April 21, 2011

**Subject: Bull Hill Wind Project: DP 4886: Application Amendment: Vernal Pool Redesign**

Client/Project  
**Blue Sky East Wind, LLC**  
 Bull Hill  
 Eastbrook and T16MD, Maine  
 Figure No.  
**3**  
 Title  
**Delineated Natural Resource Map**  
 December 2010  
 rev. April 21, 2011

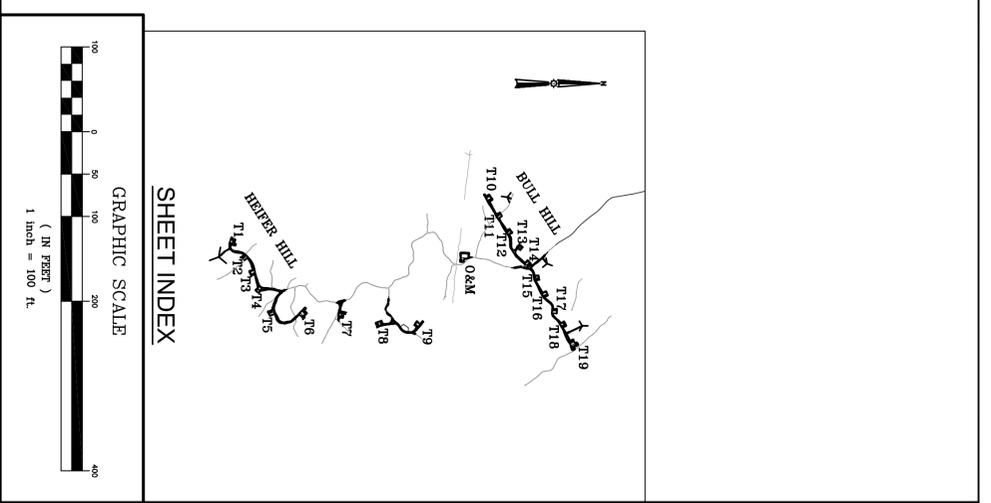
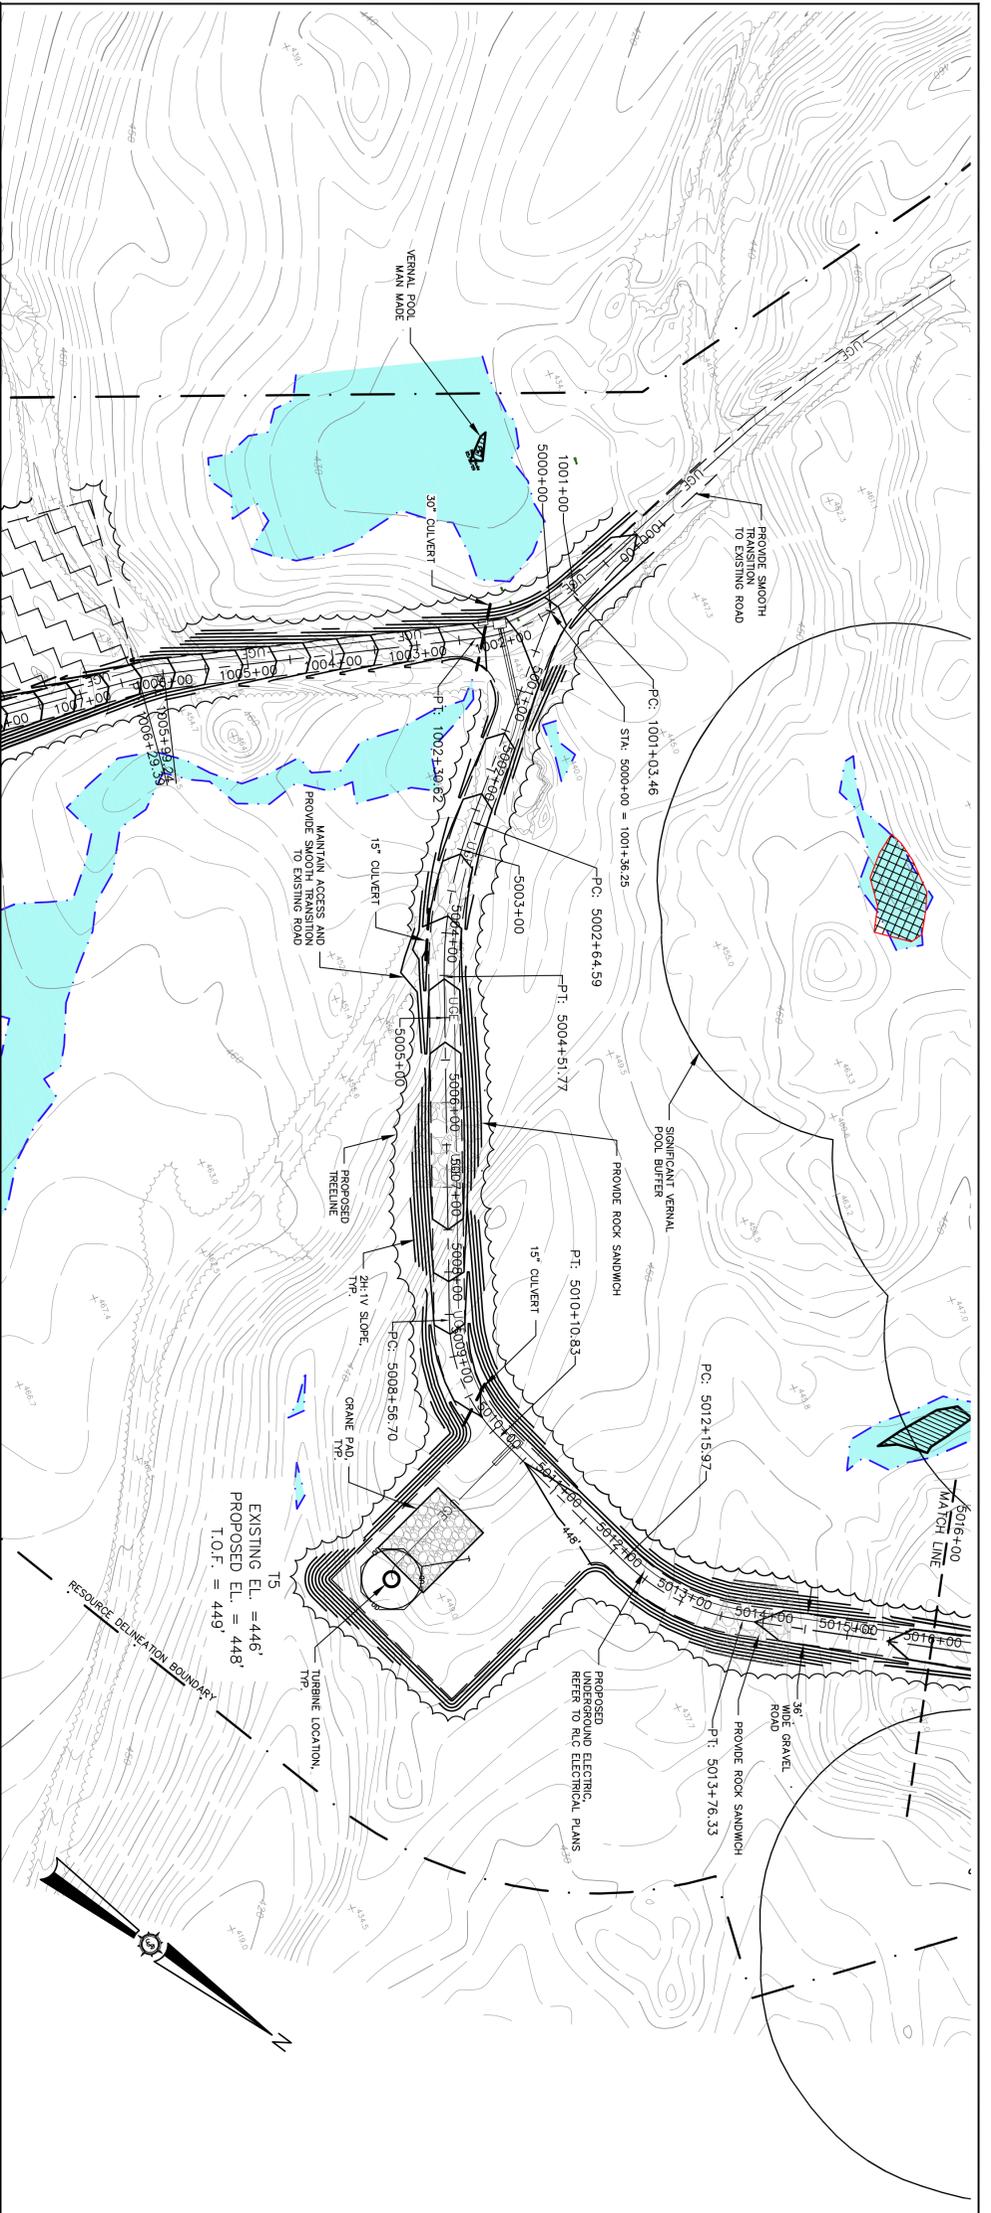
Directing your attention to civil design plan C-103 and natural resource map Figure 3, there is a wetland on the edge of the delineation area, designated as A063 on Figure 3. This wetland was delineated in August 2010. In addition to being a wetland, it was also determined, based on topography and seasonal indicators, to be a potential vernal pool (PVP). It could not be confirmed as a vernal pool due to the time of year it was evaluated.

For regulatory purposes, IFW considers PVP's as Significant Vernal Pools unless and until a survey in seasonally appropriate conditions determines otherwise. Although this location was included as a wetland in our natural resource data inventory, it was not included as PVP. As a result, a 250-foot Significant Vernal Pool buffer was not applied to this PVP in the electronic data used to prepare the civil design maps in Exhibit 1A (Sheet C-103), or natural resource maps in Exhibit 12A (Figure 3, wetland A063).

Upon realizing the error, we determined that the current project design impacts 14.4 percent of the PVP buffer. Although less than the regulatory impact standard of 25 percent, we also determined that the project could be redesigned with a short road realignment. The project has been redesigned to completely eliminate any impact to the PVP buffer by moving the road further from the PVP.

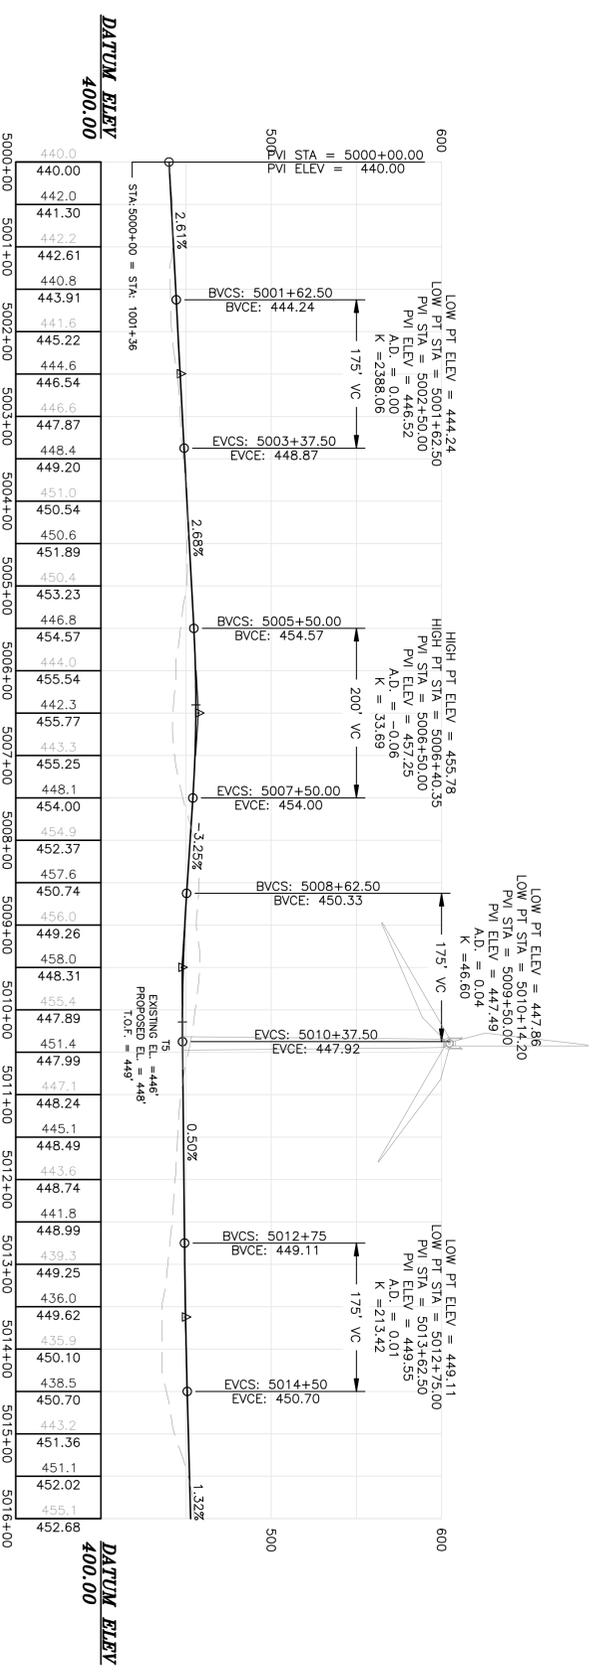
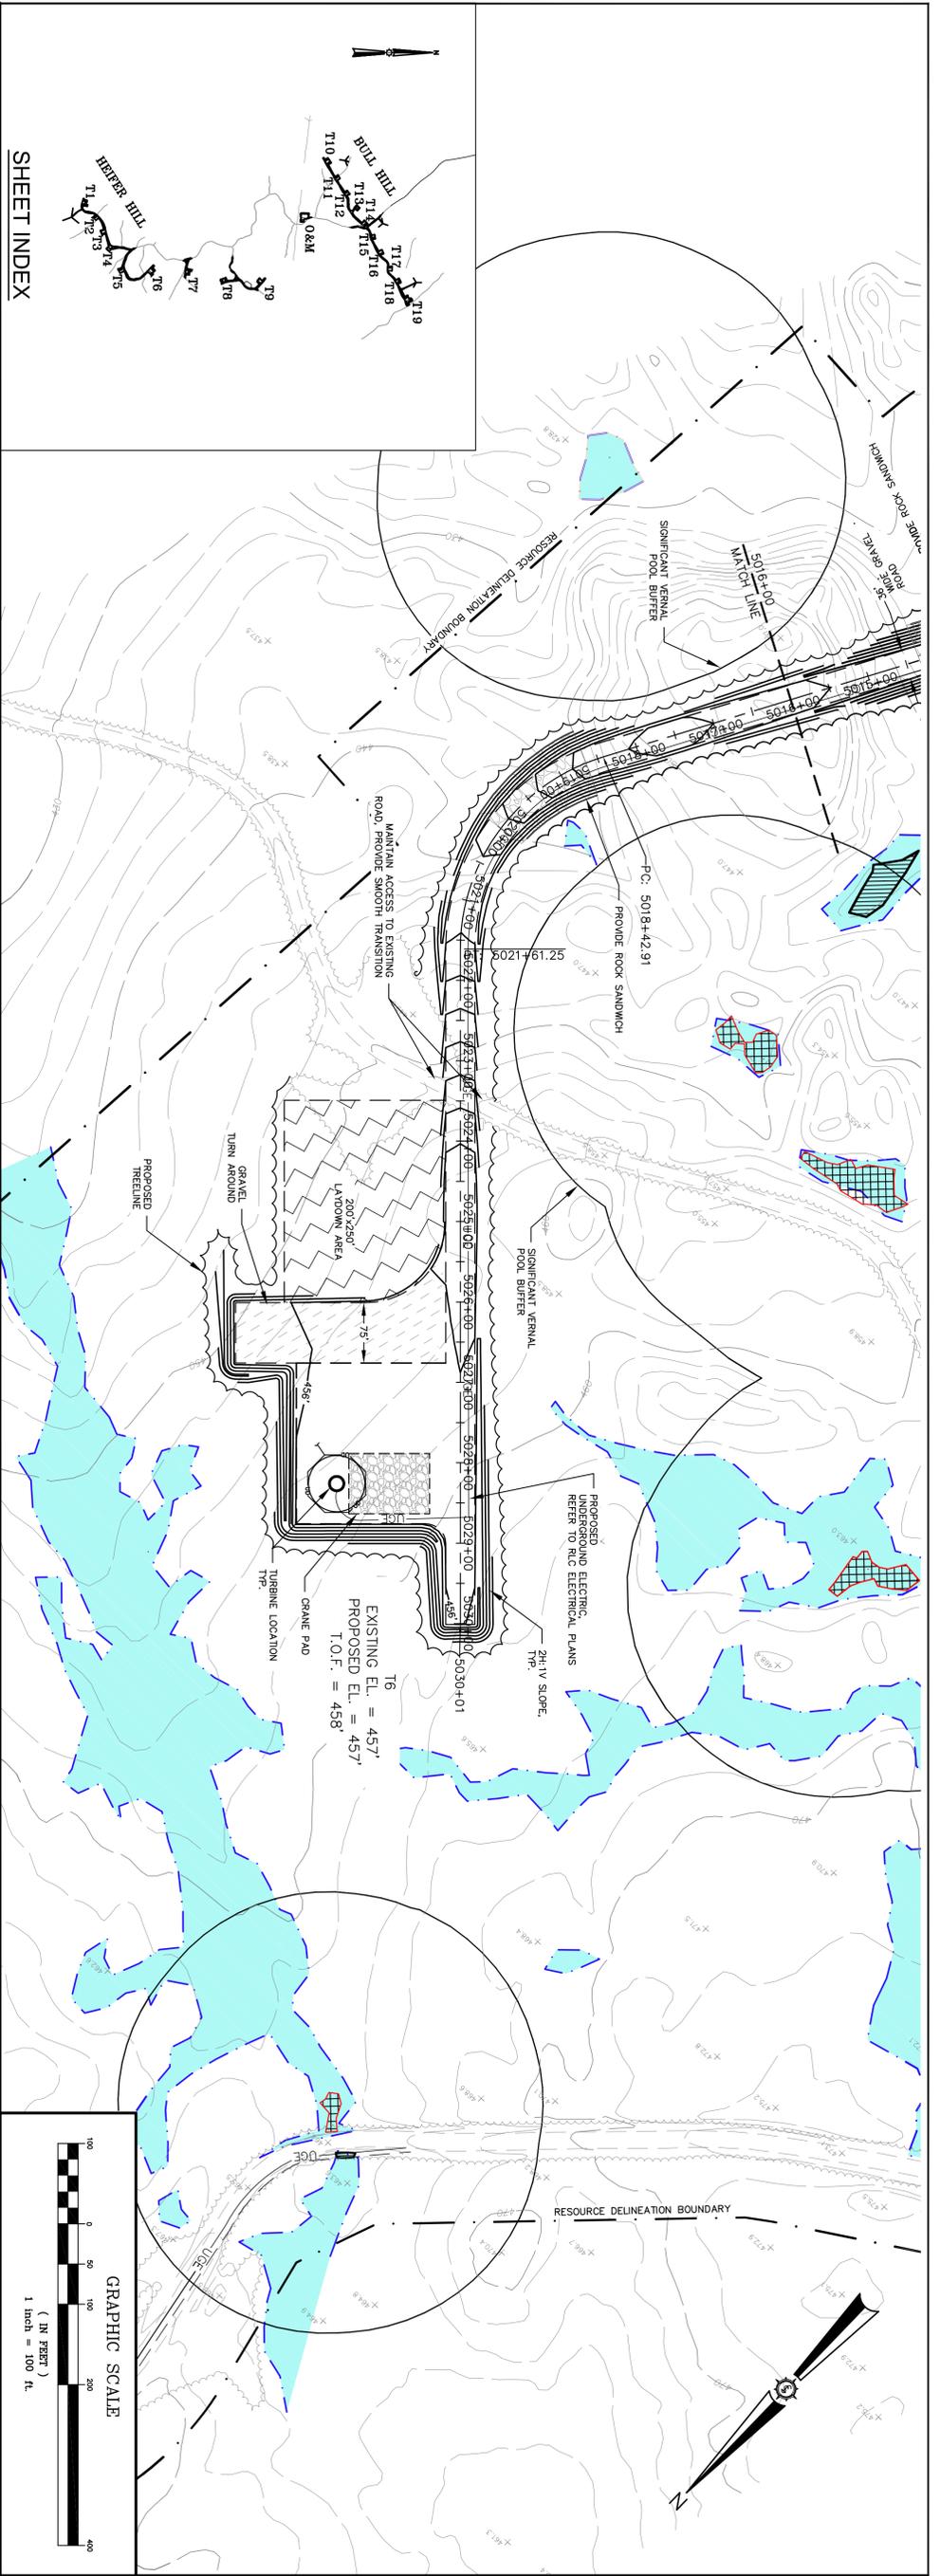
<table><tr> <th>Rev. #</th> <th>By</th> <th>Description</th> <th>Date</th> </tr><tr> <td>3</td> <td>JLD</td> <td>REVISED T5-6 CRANE PATH TO AVOID SVP BUFFER</td> <td>4/21/11</td> </tr></table>

Sheet No. **C103**

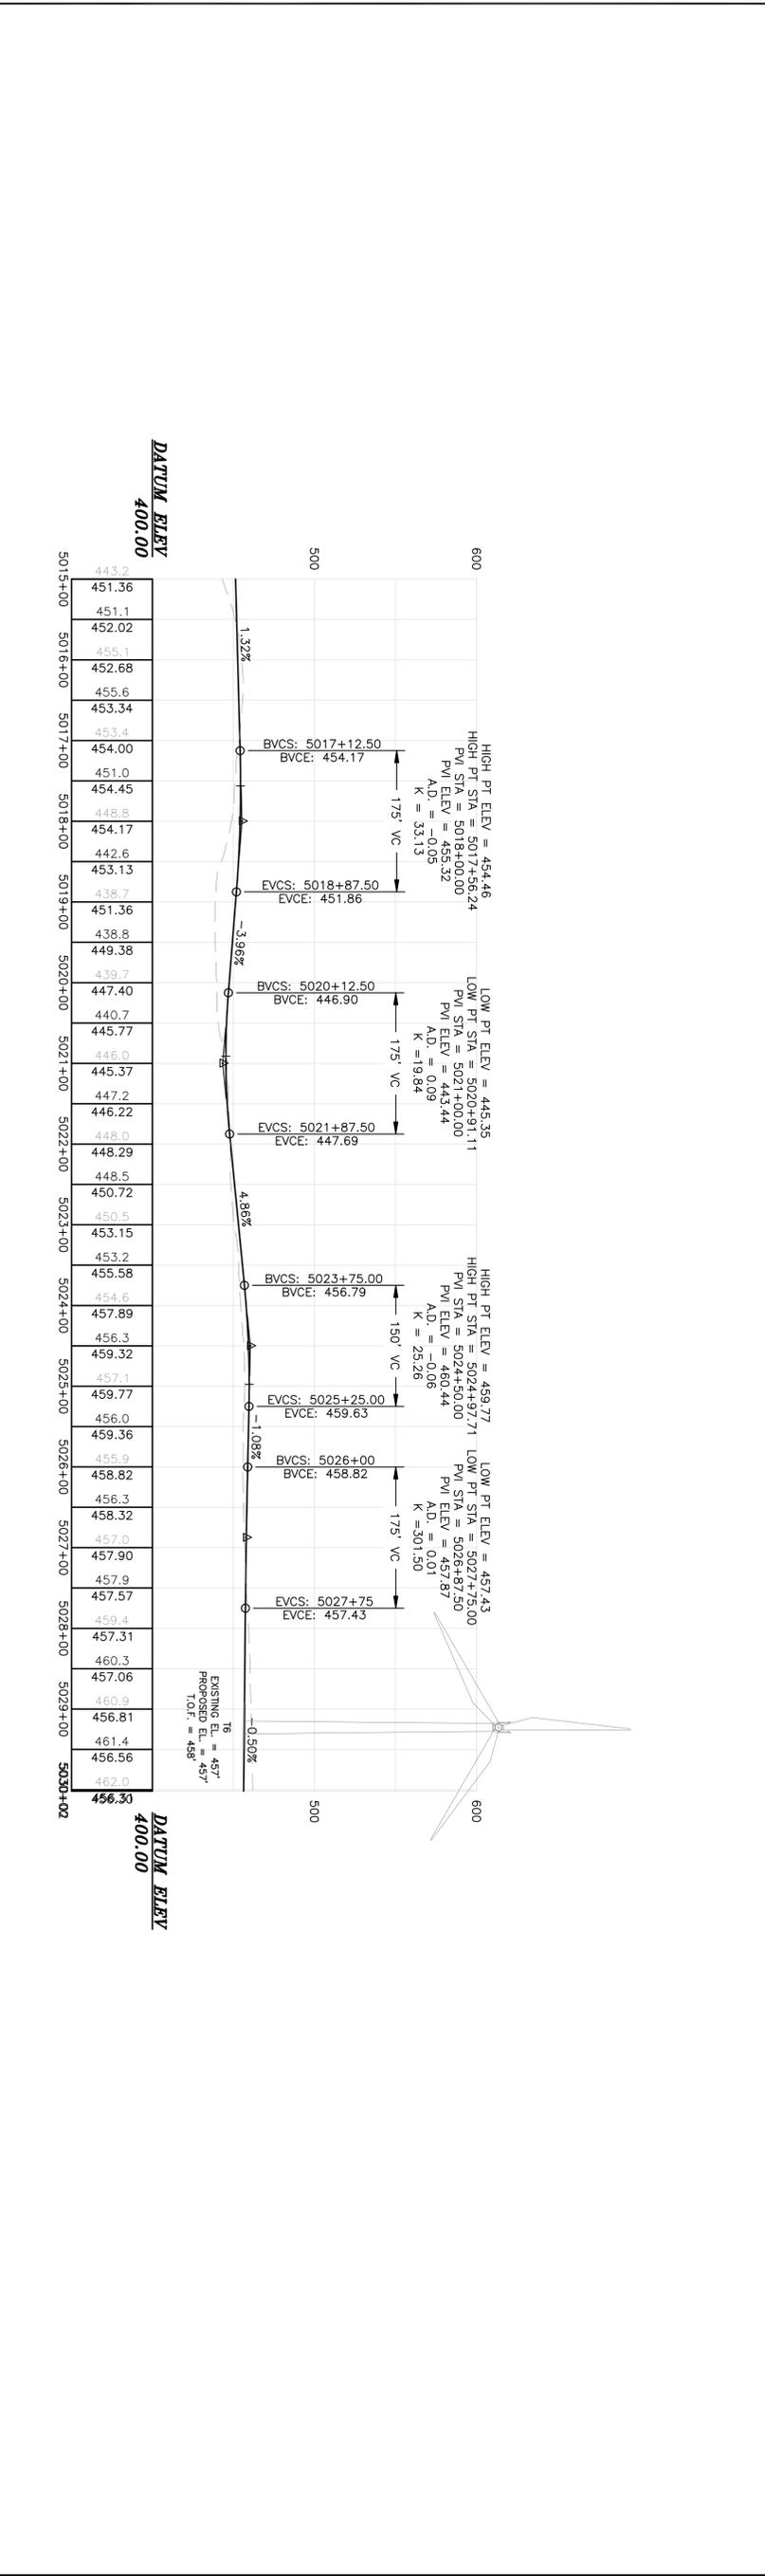
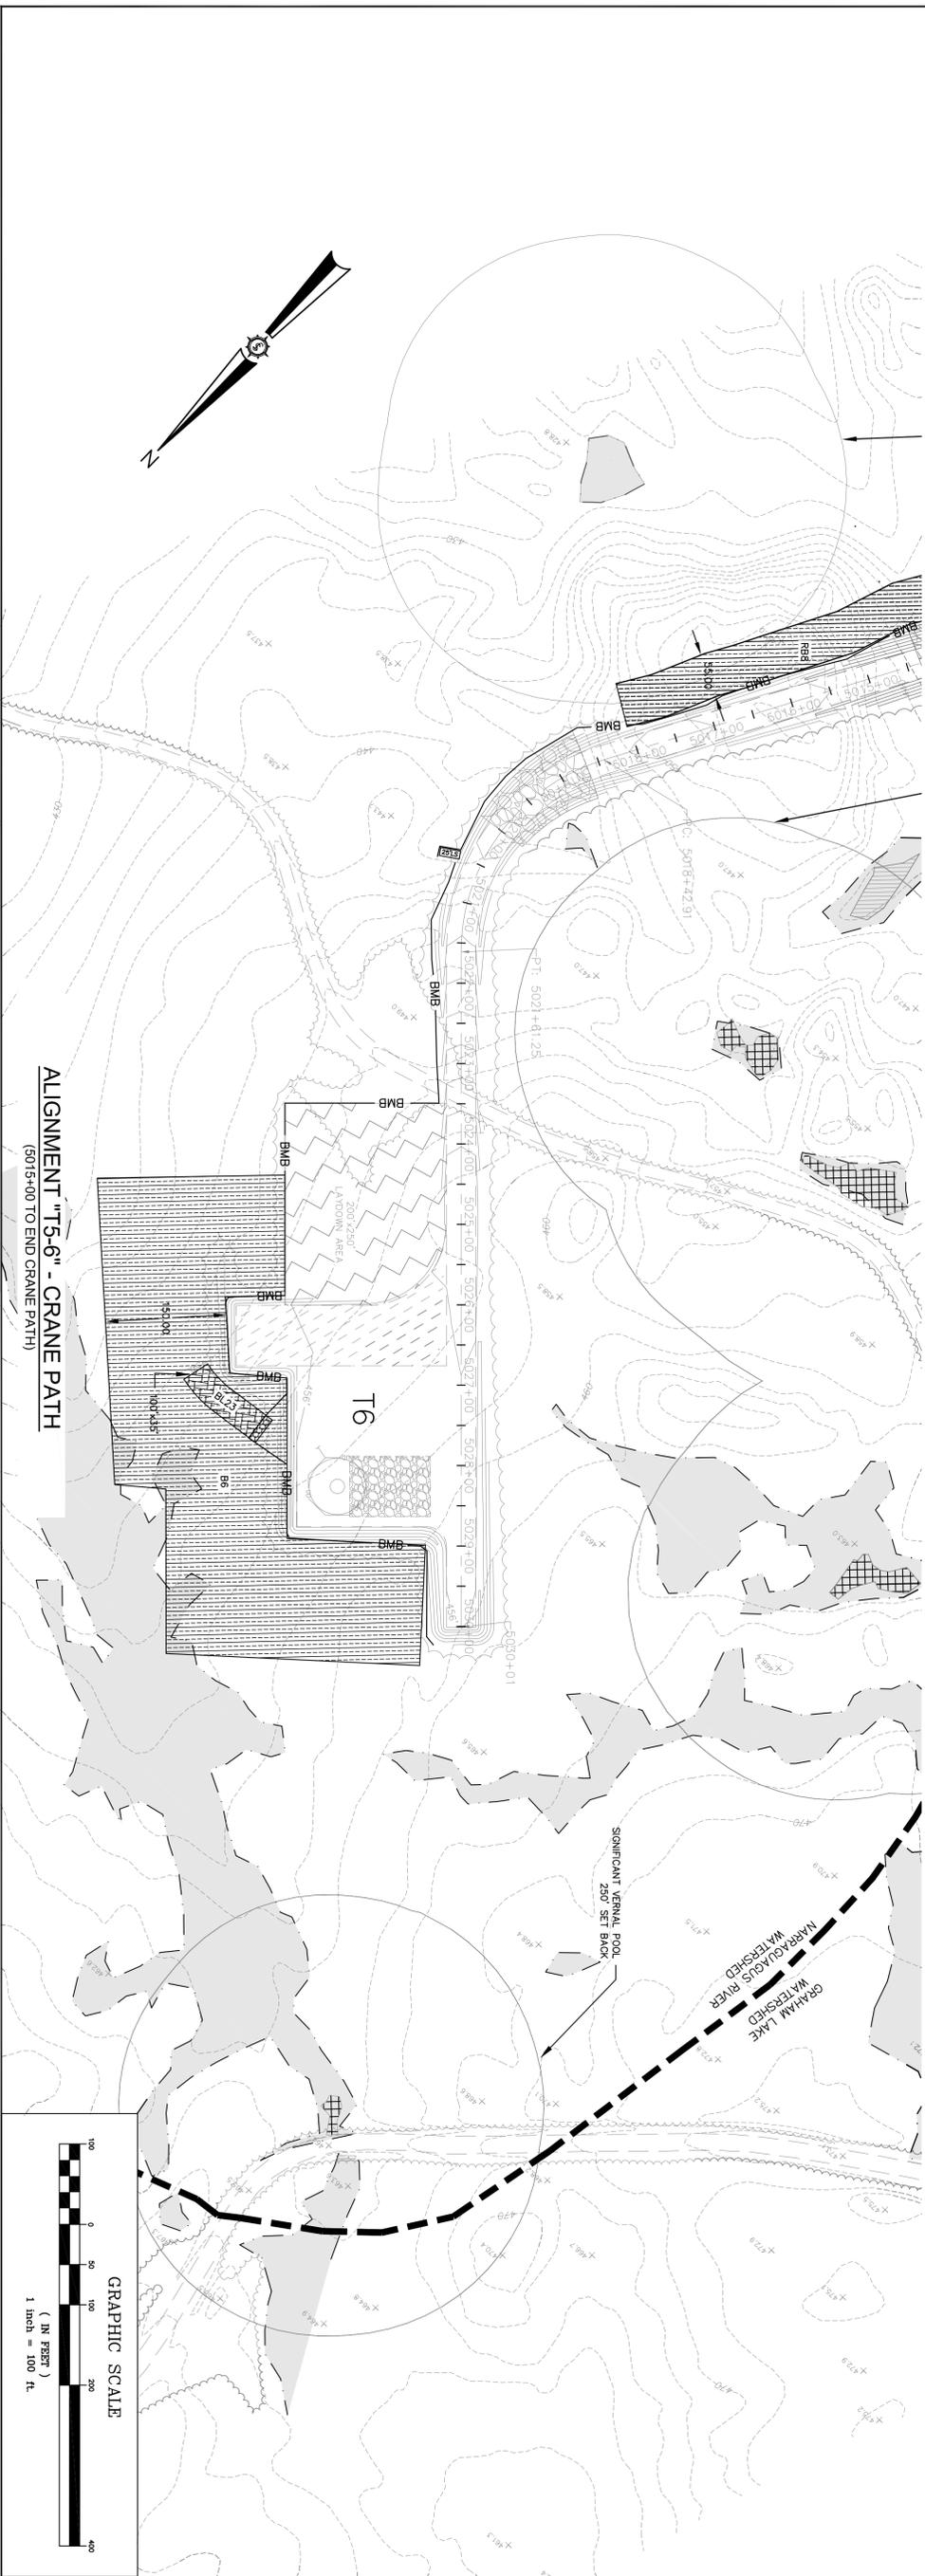
Rev. #	Desig. By	Description	Date
1	JLD	REVISED PER LURC COMMENTS DATED 01/18/11	1/25/11
2	JLD	REVISED PER AGENCY COMMENTS DATED 04/11/11	4/15/11
3	JLD	REVISED T5-6 CRANE PATH TO AVOID SVP BUFFER	4/21/11
